Design Review Board Agenda

| A. Vintage at Mill Creek PL 2015-0017 – Building Elevations and Landscaping ⁽²⁾ | |

**CITY OF MILL CREEK
DESIGN REVIEW BOARD MEETING MINUTES
May 19, 2016**

L1.1
LANDSCAPE PLAN

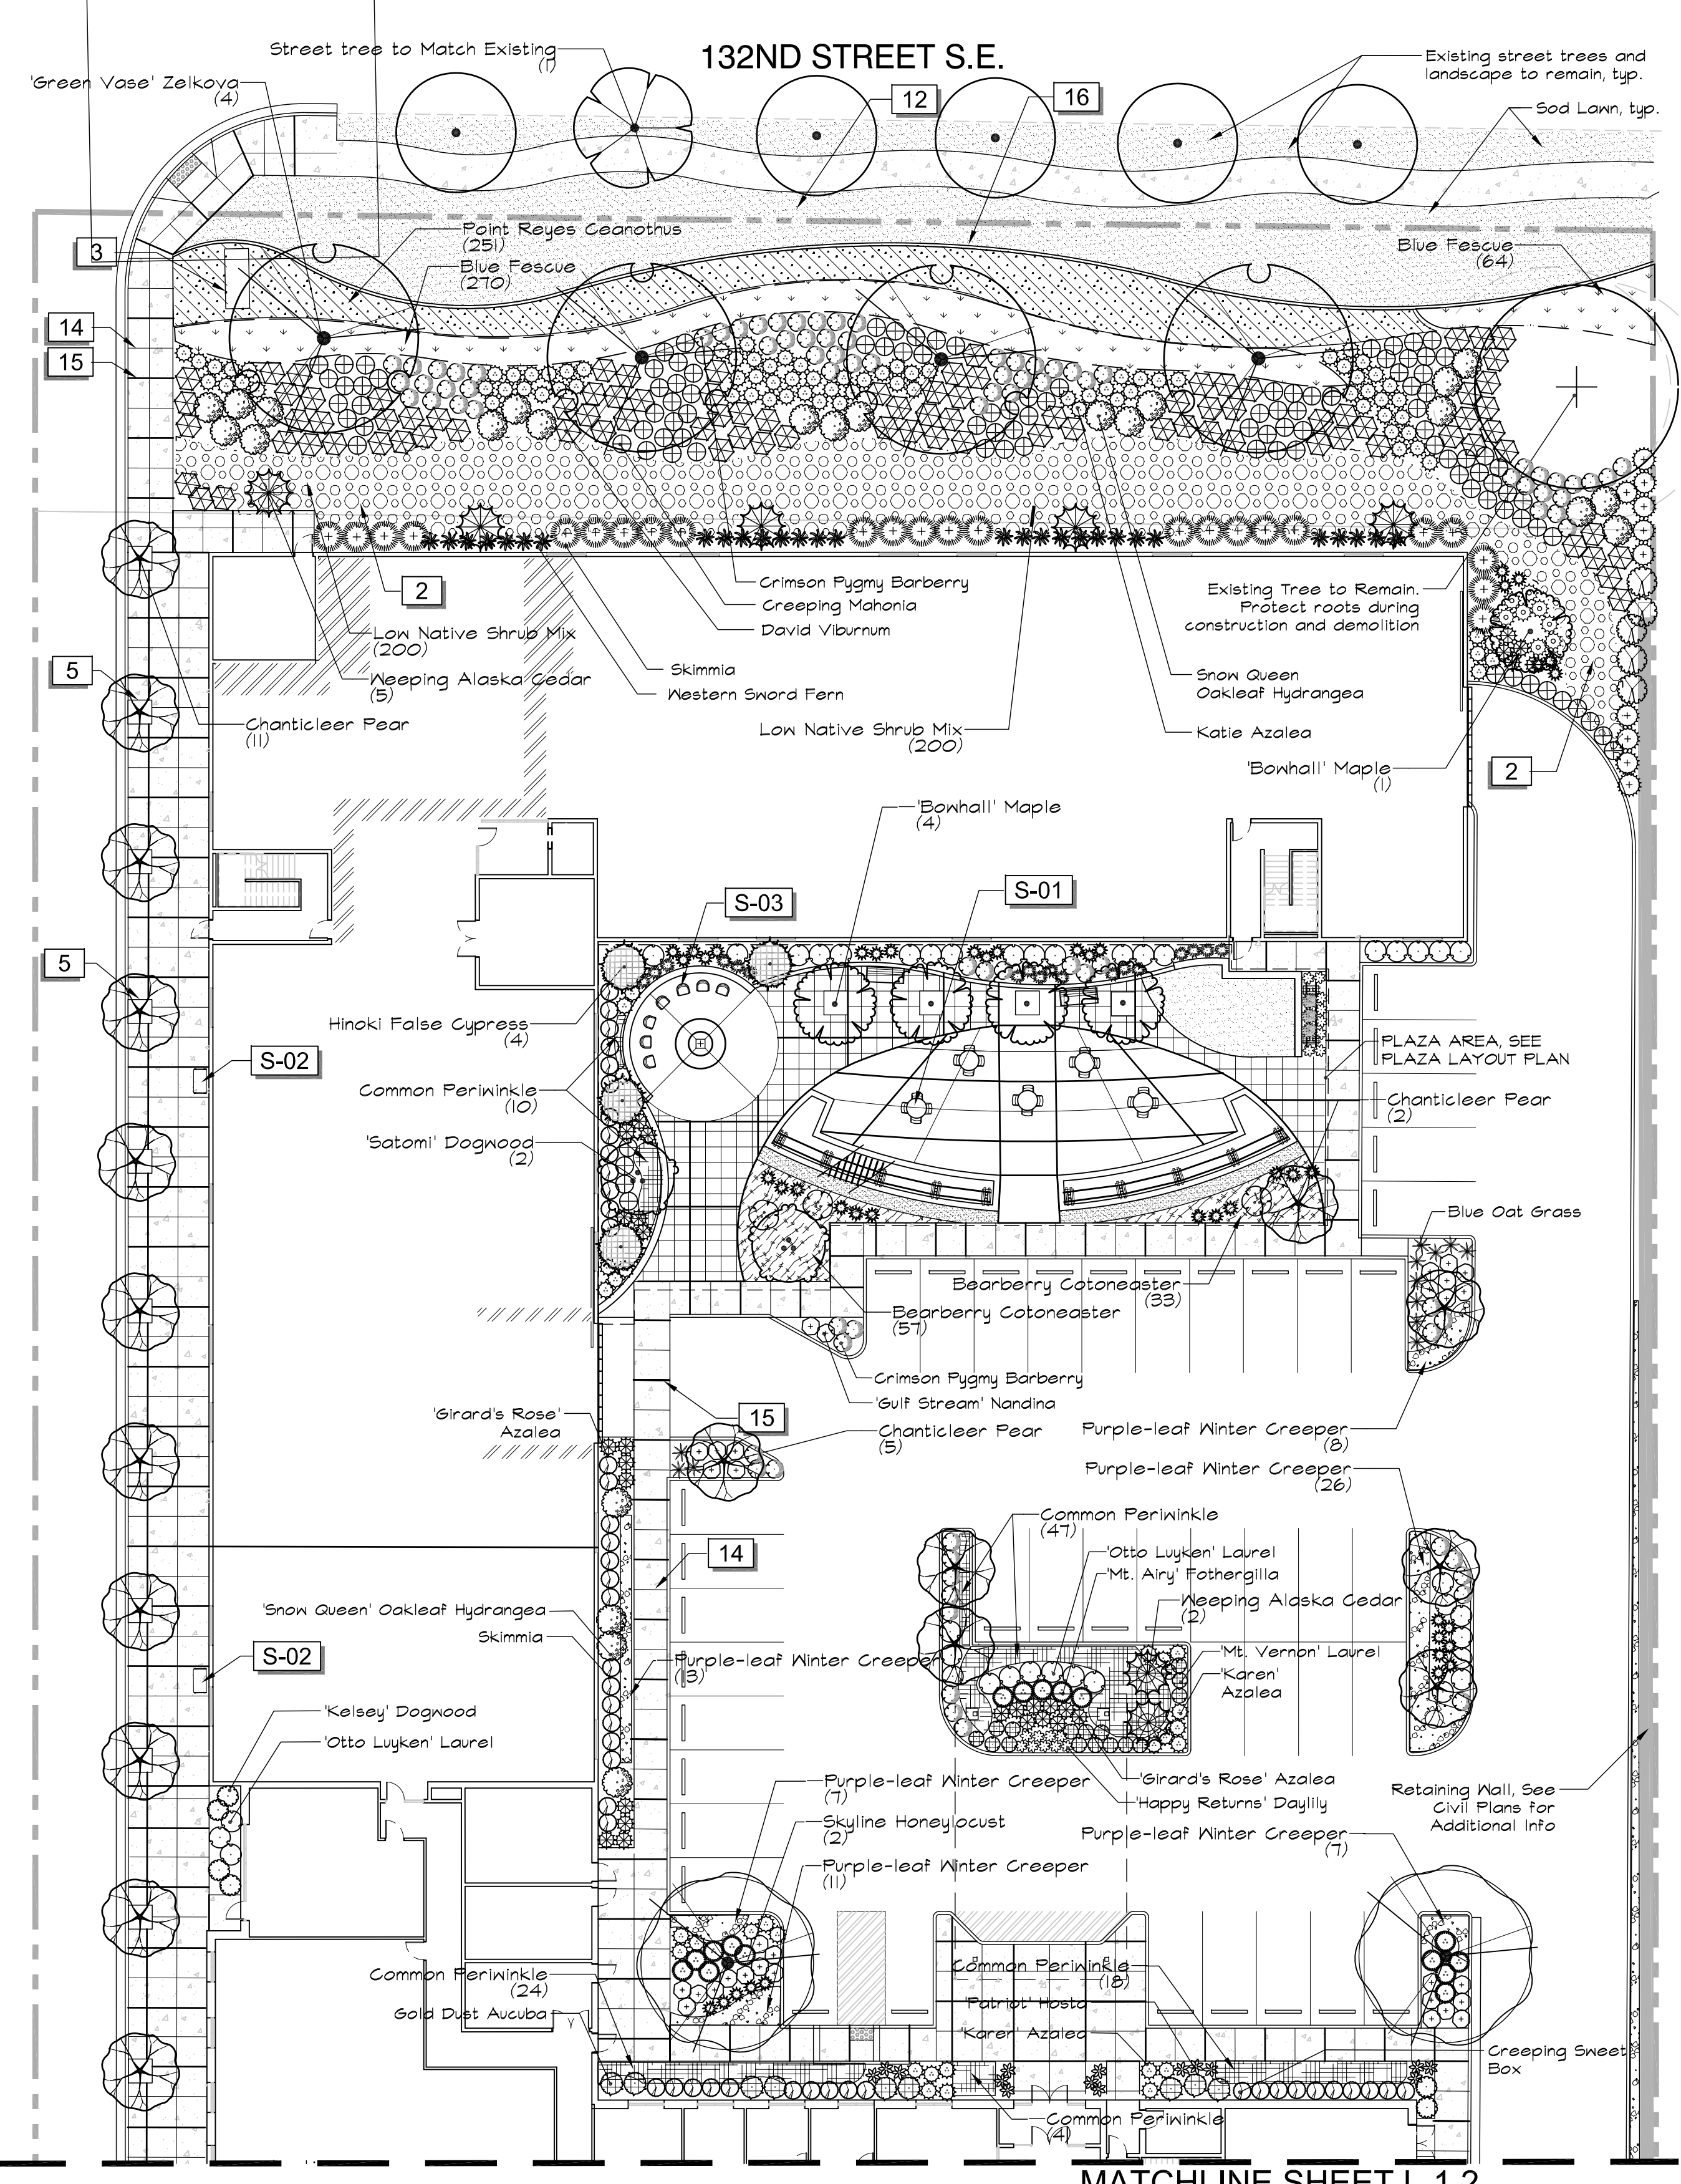
In the parking lot adjacent to Building 2, Oregon Grape are proposed in the narrow planting bed between the retaining wall and the drive aisle on the eastern property boundary. Oregon Grape do not typically do well in hot, dry soils (such as in parking lots or strips); thus, staff is recommending that the applicant choose another shrub better suited to this location.

The perimeter buffer will feature a 6-foot concrete sidewalk, which will eventually connect to the east and west as the adjoining properties develop. The sidewalk meanders through a buffer planted with native shrubs. The Landscape Plan shows four trees to be saved; however, in the Tree Protection Plan, submitted with the Binding Site Plan application, five trees are proposed to be saved. In the perimeter buffer along the southern property boundary Tree #25 Cedar, Trees #21 and #22 both Cedar, Tree #16 Cedar, and Tree #14 Douglas fir. As a Condition of Approval, staff is requesting that the applicant change the landscape plan to accurately identify the trees to be retained.

There is a Cedar (Tree #15 on the Tree Protection Plan) close to the Douglas fir (#14) that has not been proposed to be saved. The Tree Protection Plan identifies this tree as being in fair condition and stated that it could potentially be saved. Given the proximity to the Douglas fir and the fact that it is likely far enough away from the proposed garages to be saved, staff is recommending that this tree also be retained if possible.

4. Wheel stops shall be provided adjacent to walkways and landscape areas, per MCMC 17.34.040.H.2.C.
5. Modify the landscape plan as follows:
 - Correct the landscape plan to accurately show the trees to be retained. In accordance with the Tree Protection Plan, submitted with the Binding Site Plan application, seven trees are proposed to be saved. In the northeast corner of the roadway buffer two Douglas fir (Trees #33 and #34), and in the perimeter buffer along the southern property boundary Tree #25 Cedar, Trees #21 and #22 both Cedar, Tree #16 Cedar, and Tree #14 Douglas fir. In addition staff is recommending that Tree #15 Cedar also be retained if possible.

- Select another species with a wider mature spread to substitute for the Bowhall Maple proposed in the perimeter buffer.
 - Select another shrub, which is better suited for the planting conditions, to substitute for the proposed Oregon Grape in the narrow landscape bed between the retaining wall and the pavement on the eastern property boundary adjacent to Building 2.

01 SITE PLAN - SIGN LOCATION

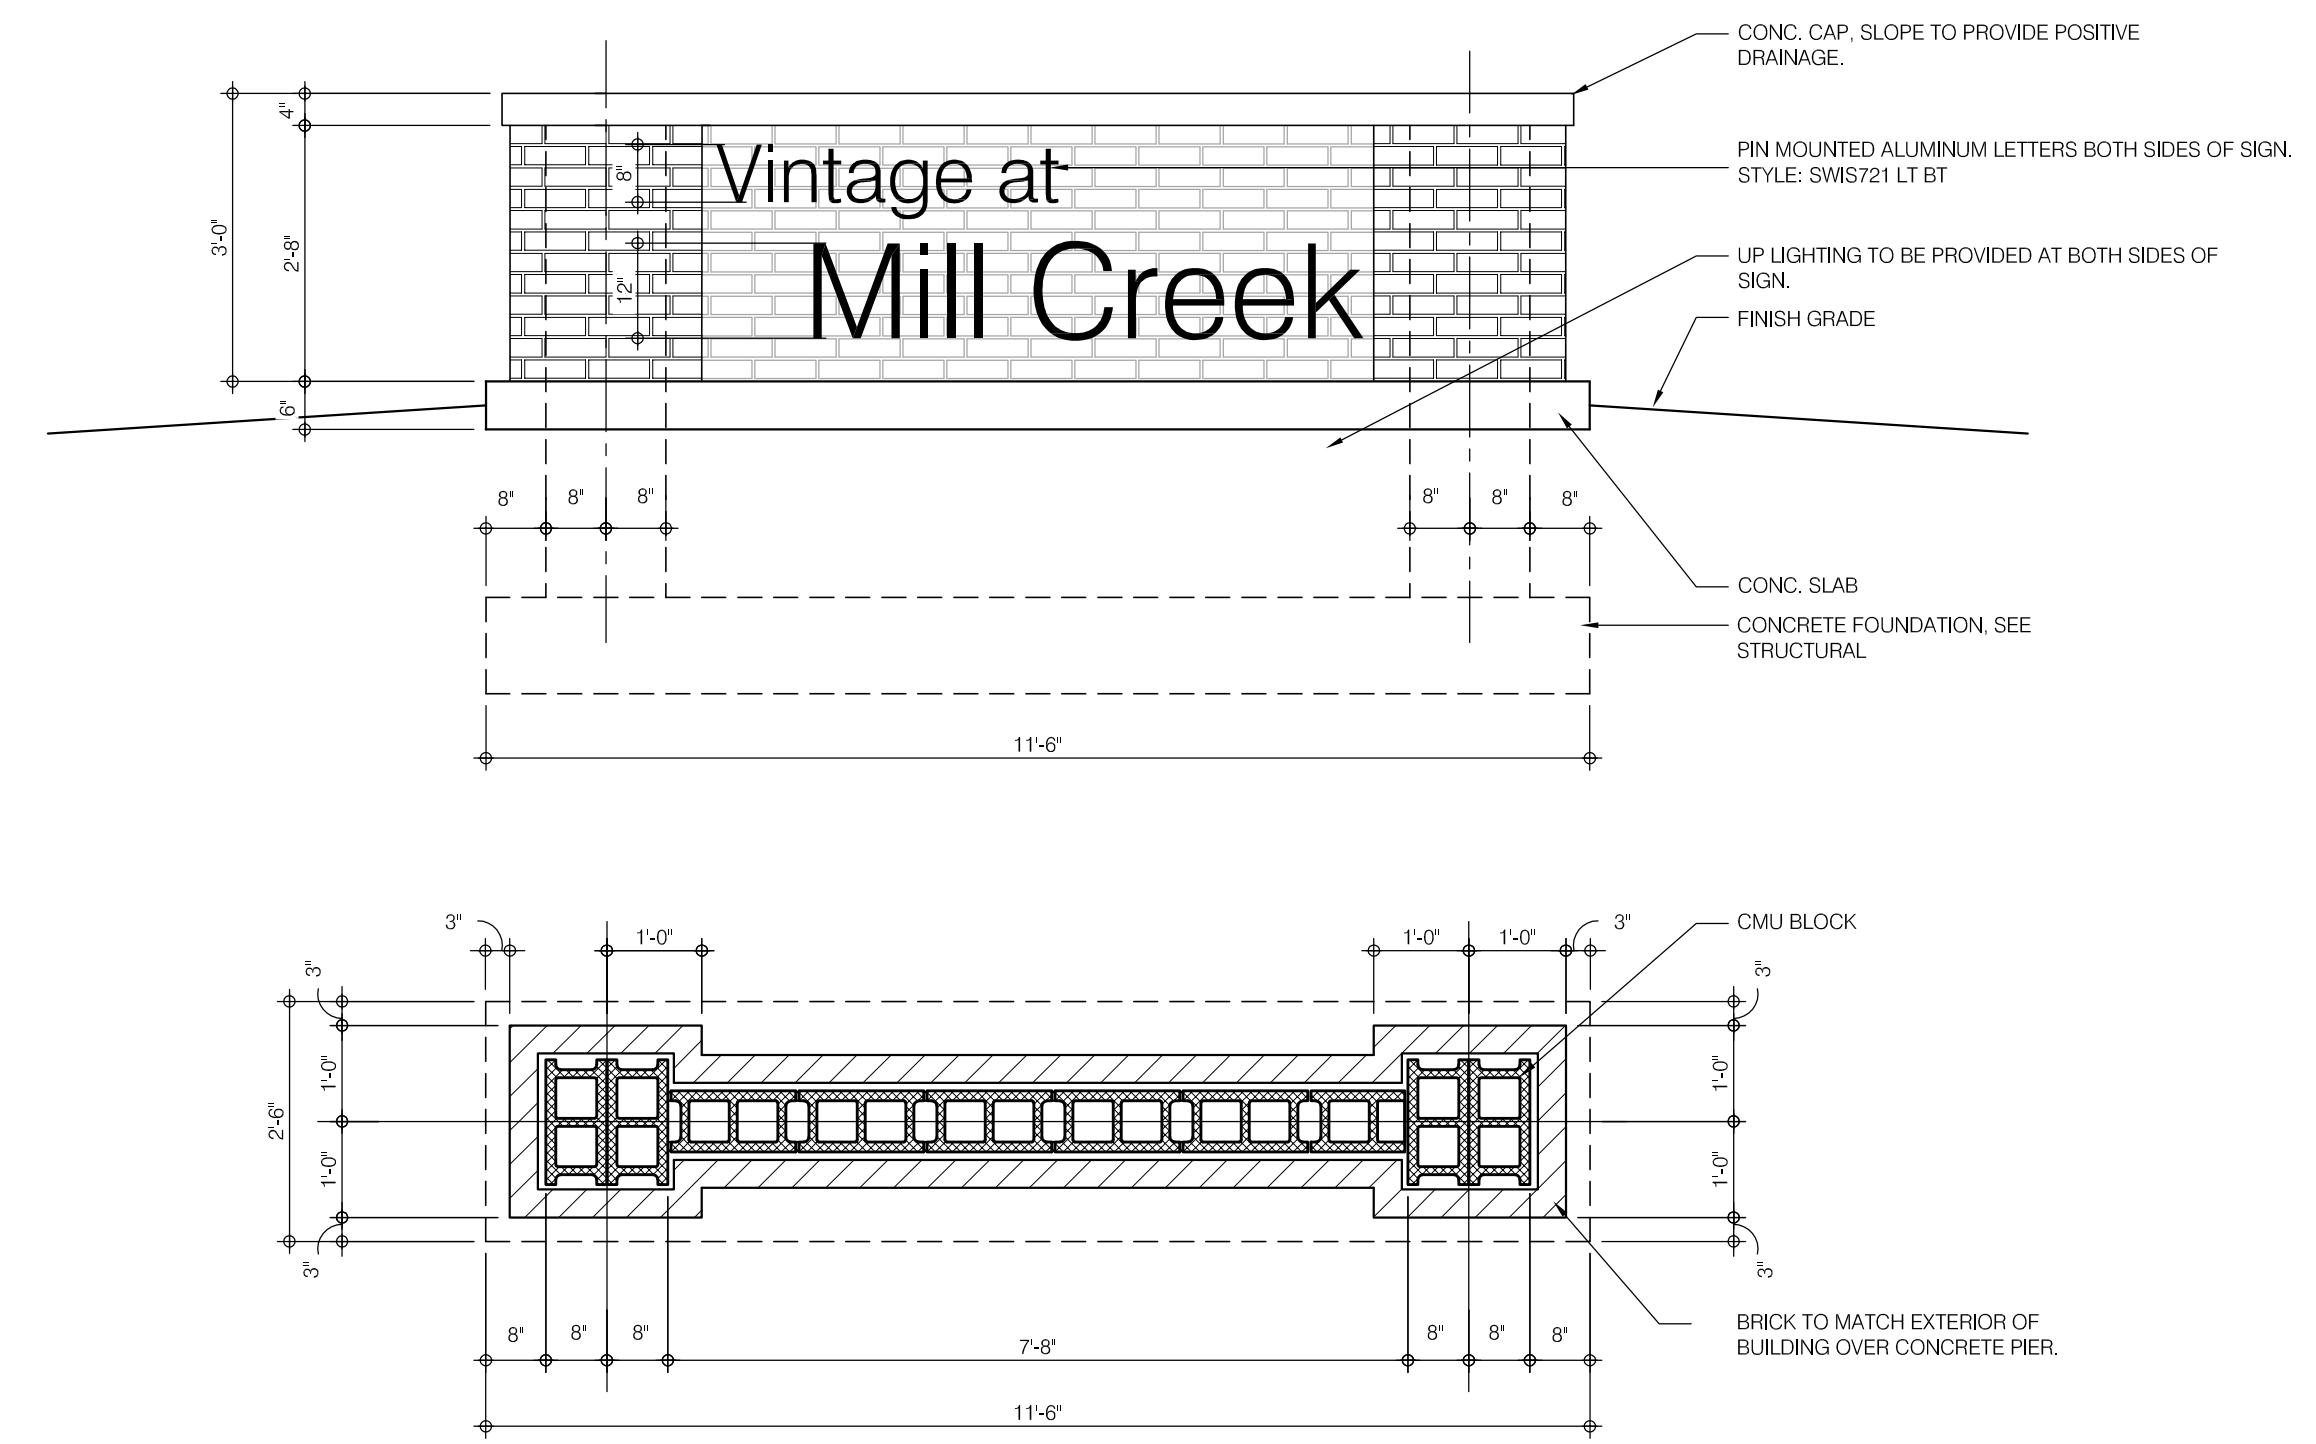
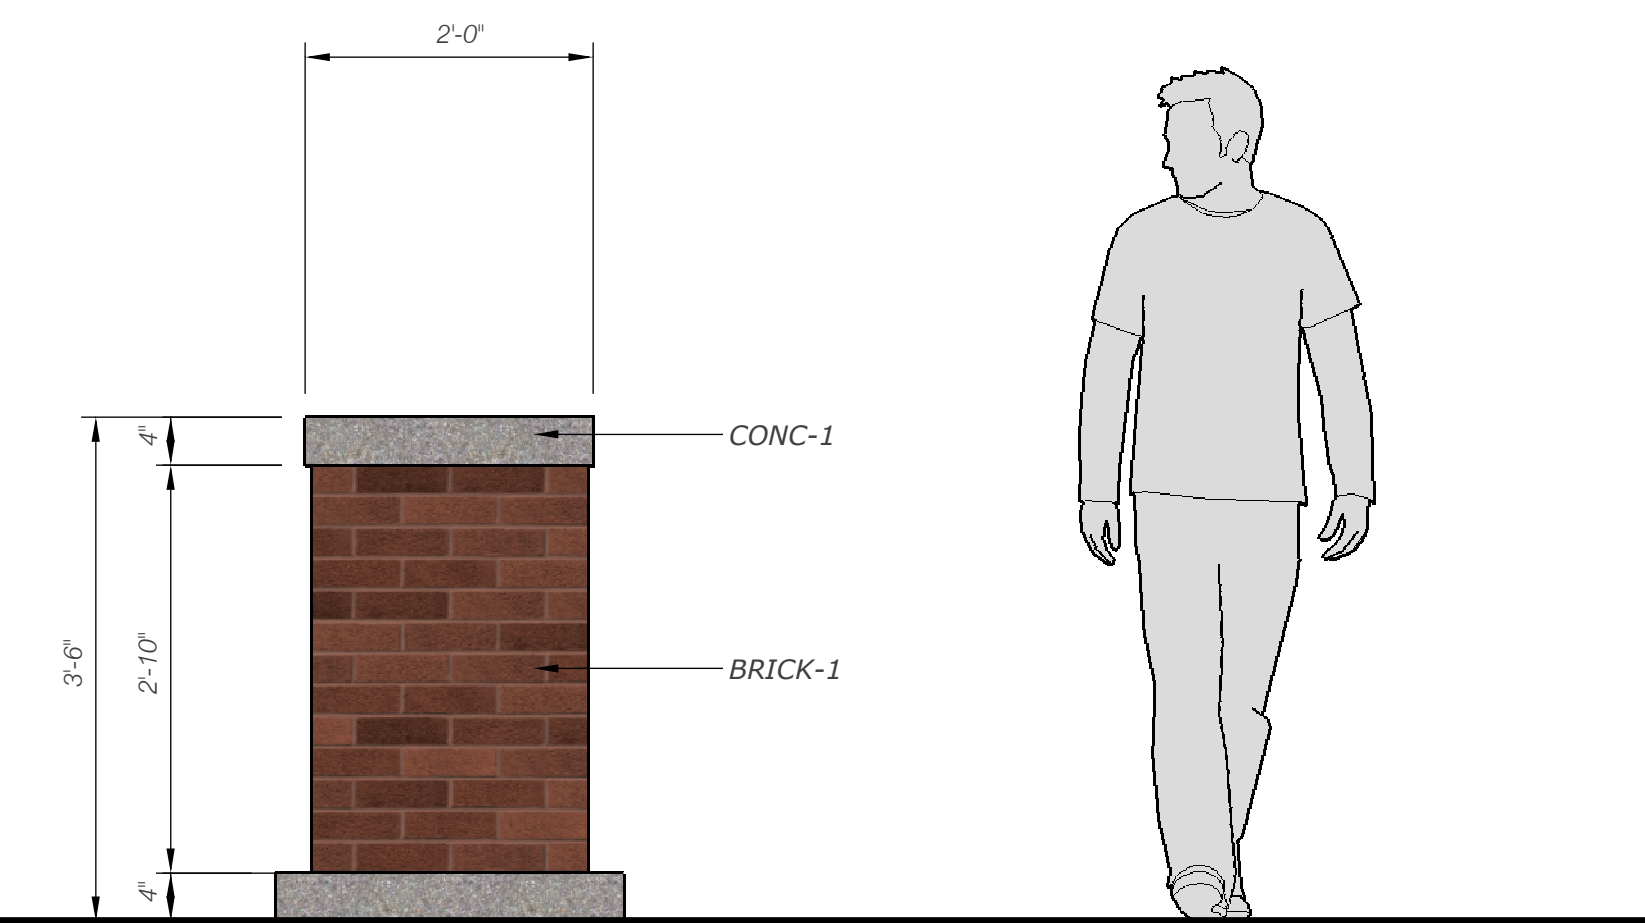
On the east side of 41st Avenue SE the applicant is proposing to install a double-faced brown brick monument sign with a 16 square foot sign face area and additional supporting columns, per MCMC 17.26.020.E.7. The sign is 42 inches high with up-lighting. Lettering on the sign is proposed to read "Vintage at Mill Creek" to identify the complex. See **Attachment 11, Monument Sign, Sheet A5.5**.

The proposed design is consistent with City code. However, the applicant does not show the five-foot setback from the right-of-way. Therefore, staff is requiring that the five-foot setback be shown on the building permit application for the monument sign.

1. The design, colors and building materials shall be as portrayed on the application, except as revised in the conditions below.
2. Submit a utility plan showing the location, size and screening of the utilities for City review and approval prior to issuance of the clearing and grading plan.
3. On the Building permit submittal for the monument sign show the five-foot setback from the right-of-way.
